GW - 183

**GENERAL
CORRESPONDENCE**

**Re: Discharge Plan Renewal GW-183
Arch Rock Compressor Station**

**Re: Discharge Plan Renewal GW-183
Burlington Resources
Arch Rock Compressor Station
San Juan County, New Mexico**

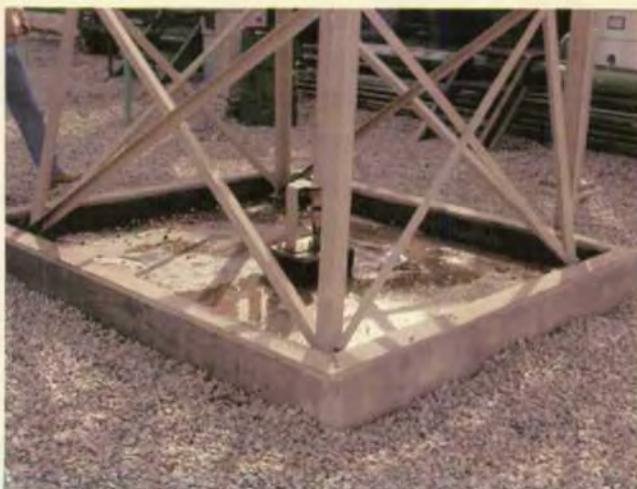
Entrance sign.

Saddle tank, showing leakage.
See inspection sheet notes.

Sump. Full and needs to be drained.
See inspection sheet notes.
